Sheet: /
File: launchpad-controller-v2.kicad_sch

Title:
Size: A1 Date: Rev:
KiCad E.D.A. 8.0.0 Id: 1/43

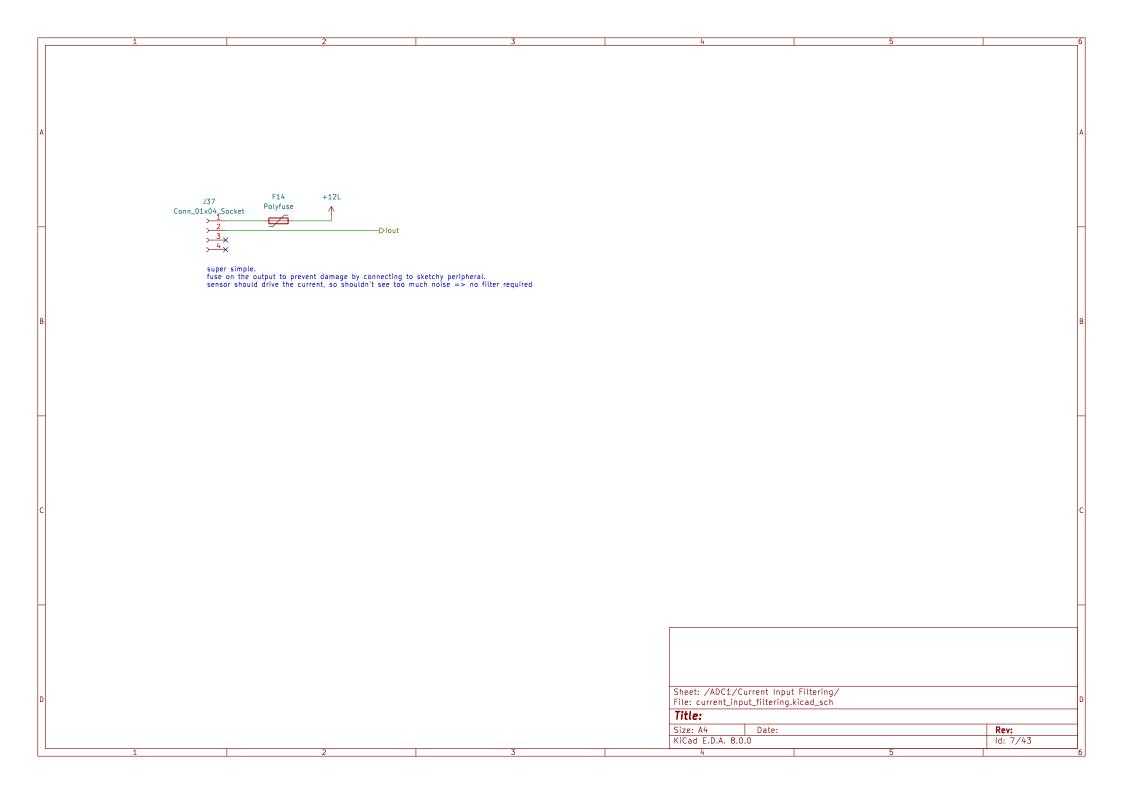
Would remove the connector from this sheet. Move to root sheet. Nah fuck that $% \left(1\right) =\left(1\right) \left(1\right) \left($ Unless someone else wants to... Cutoff frequency of 1.5915 kHz Bidirectional TVS Diode with clamp voltage of 36V. Maybe switch to 24V clamp. F3 +12L J22 Polyfuse Conn_01x04_Socket R69 1 k D1 SD36_SOD323 C93 100n GND OWD_COMPLX Not gonna do open—wire detection. Left it as a NC to make it easier to add later though Sheet: /ADC1/Voltage Input Filtering/ File: voltage_input_filtering.kicad_sch Title: Size: A4 Date: KiCad E.D.A. 8.0.0 ld: 8/43

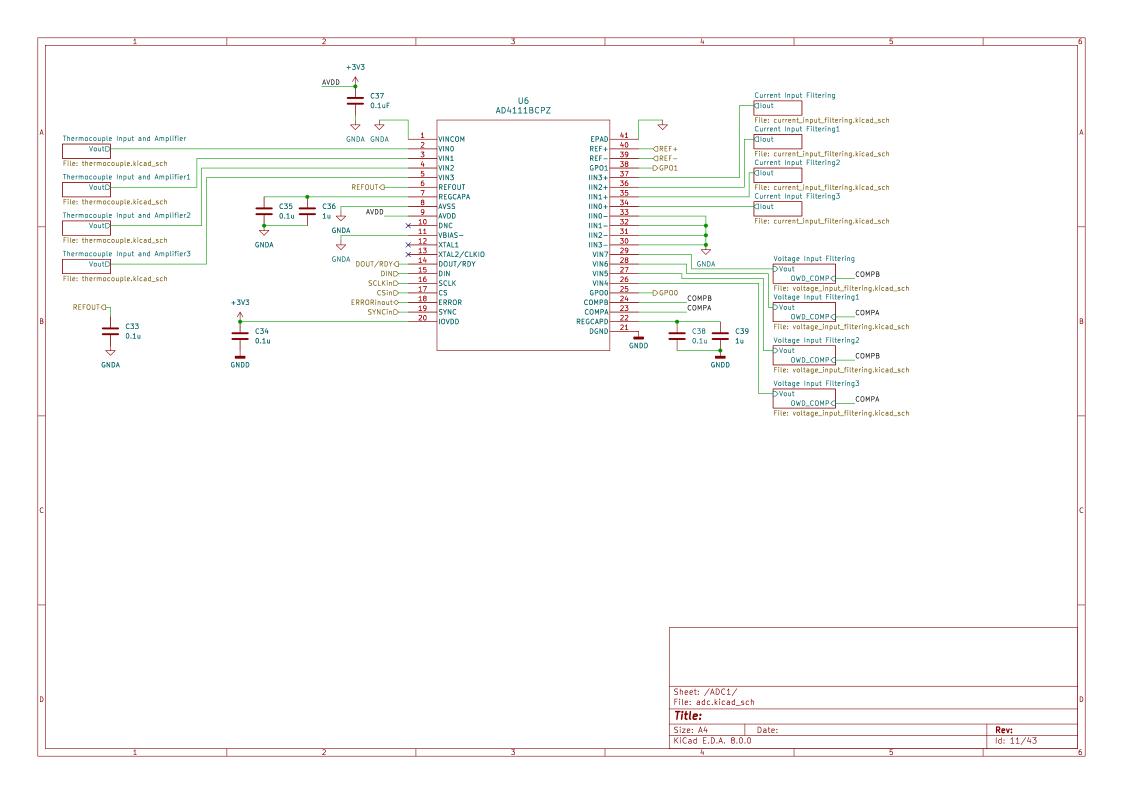
Would remove the connector from this sheet. Move to root sheet. Nah fuck that $% \left(1\right) =\left(1\right) \left(1\right) \left($ Unless someone else wants to... Cutoff frequency of 1.5915 kHz Bidirectional TVS Diode with clamp voltage of 36V. Maybe switch to 24V clamp. +12L J24 Polyfuse Conn_01x04_Socket R70 1 k D2 SD36_SOD323 C94 100n GND OWD_COMPLX Not gonna do open—wire detection. Left it as a NC to make it easier to add later though Sheet: /ADC1/Voltage Input Filtering1/ File: voltage_input_filtering.kicad_sch Title: Size: A4 Date: KiCad E.D.A. 8.0.0 ld: 12/43

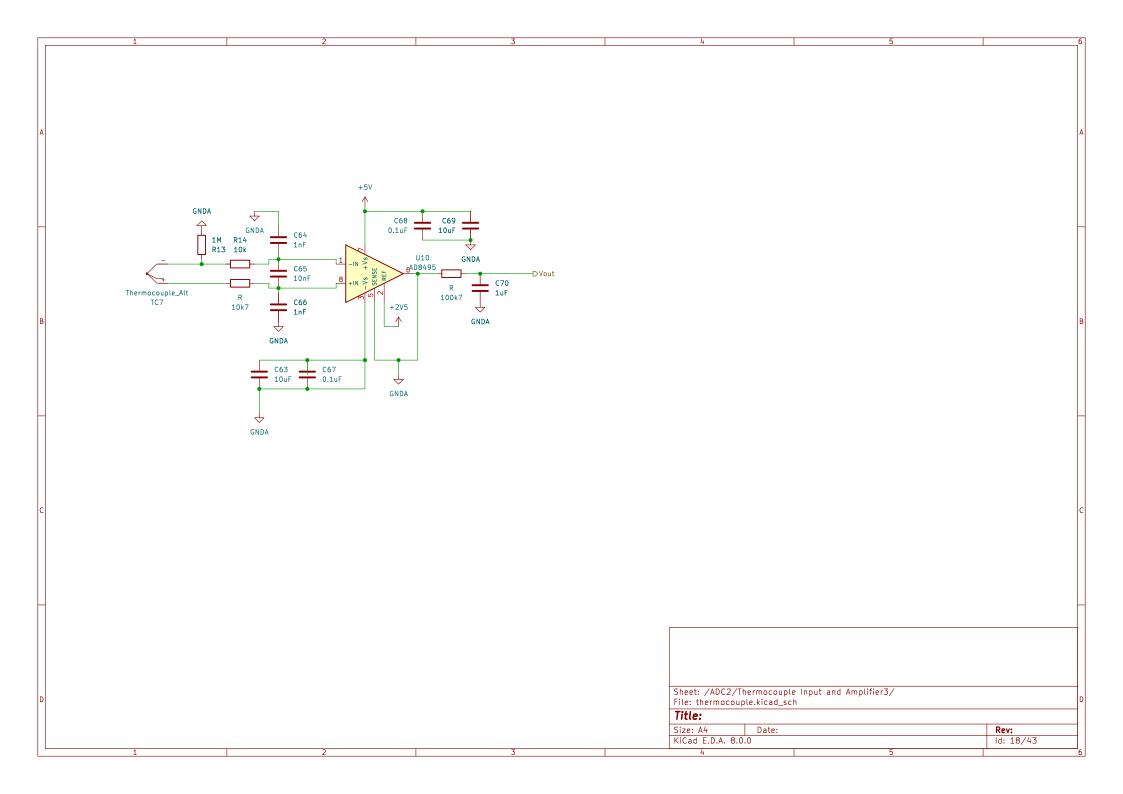
Would remove the connector from this sheet. Move to root sheet. Nah fuck that $% \left(1\right) =\left(1\right) \left(1\right) \left($ Unless someone else wants to... Cutoff frequency of 1.5915 kHz Bidirectional TVS Diode with clamp voltage of 36V. Maybe switch to 24V clamp. F6 +12L J26 Polyfuse Conn_01x04_Socket R72 1 k D24 SD36_SOD323 C96 100n GND OWD_COMPLX Not gonna do open—wire detection. Left it as a NC to make it easier to add later though Sheet: /ADC1/Voltage Input Filtering3/ File: voltage_input_filtering.kicad_sch Title: Size: A4 Date: KiCad E.D.A. 8.0.0 ld: 14/43

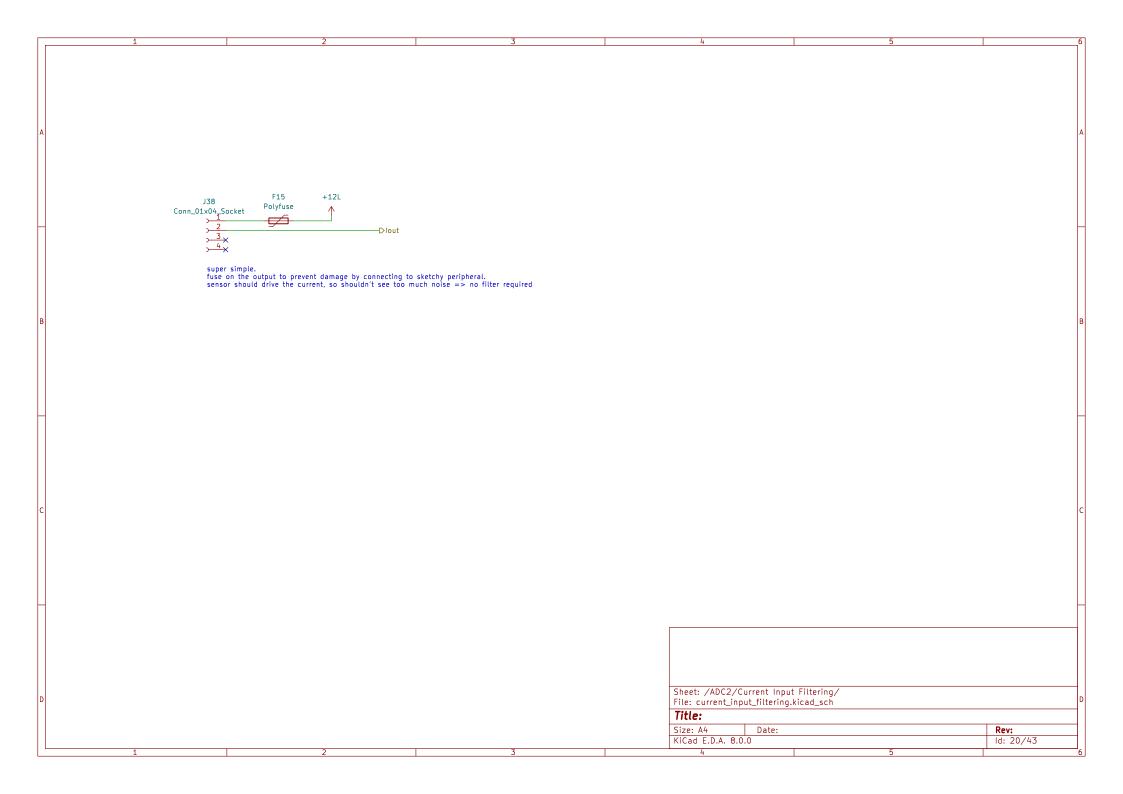
Would remove the connector from this sheet. Move to root sheet. Nah fuck that $% \left(1\right) =\left(1\right) \left(1\right) \left($ Unless someone else wants to... Cutoff frequency of 1.5915 kHz Bidirectional TVS Diode with clamp voltage of 36V. Maybe switch to 24V clamp. F8 +12L J28 Polyfuse Conn_01x04_Socket 1 k D26 SD36_SOD323 C98 100n GND OWD_COMPLX Not gonna do open—wire detection. Left it as a NC to make it easier to add later though Sheet: /ADC2/Voltage Input Filtering2/ File: voltage_input_filtering.kicad_sch Title: Size: A4 Date: KiCad E.D.A. 8.0.0 ld: 21/43

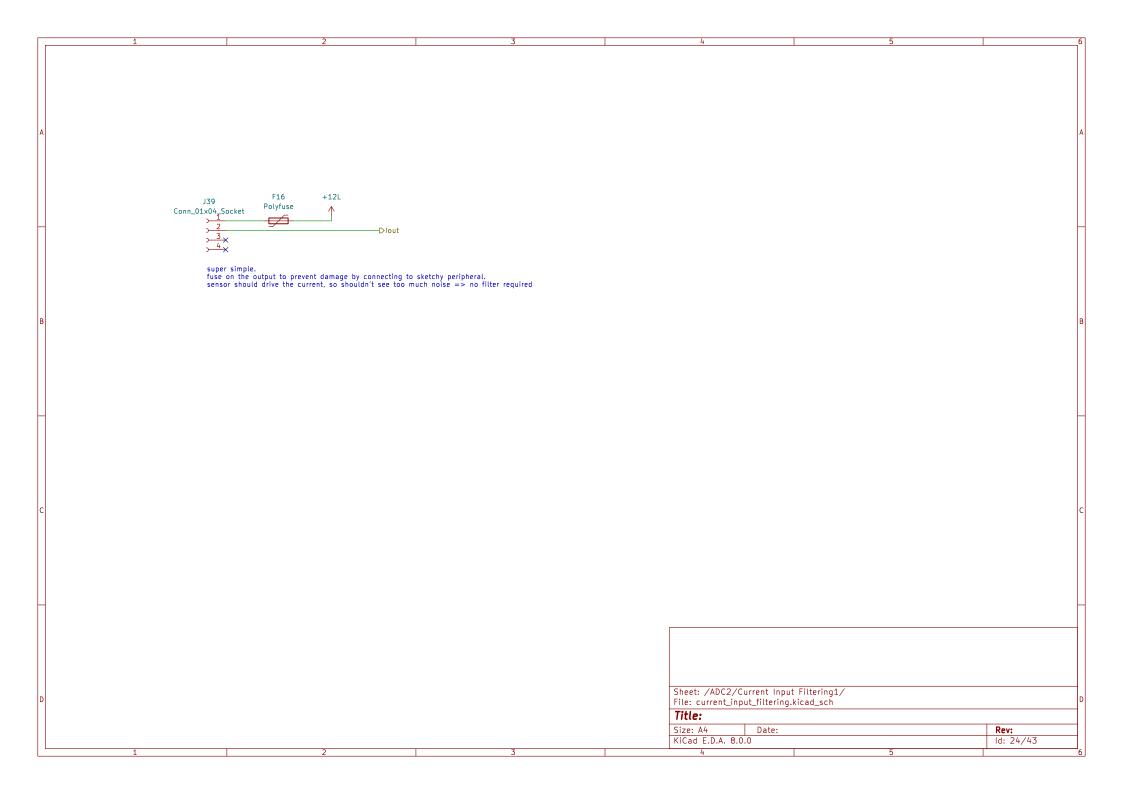
Would remove the connector from this sheet. Move to root sheet. Nah fuck that $% \left(1\right) =\left(1\right) \left(1\right) \left($ Unless someone else wants to... Cutoff frequency of 1.5915 kHz Bidirectional TVS Diode with clamp voltage of 36V. Maybe switch to 24V clamp. F9 +12L J29 Polyfuse Conn_01x04_Socket 1 k D27 SD36_SOD323 C99 100n GND OWD_COMPLX Not gonna do open—wire detection. Left it as a NC to make it easier to add later though Sheet: /ADC2/Voltage Input Filtering3/ File: voltage_input_filtering.kicad_sch Title: Size: A4 Date: KiCad E.D.A. 8.0.0 ld: 22/43
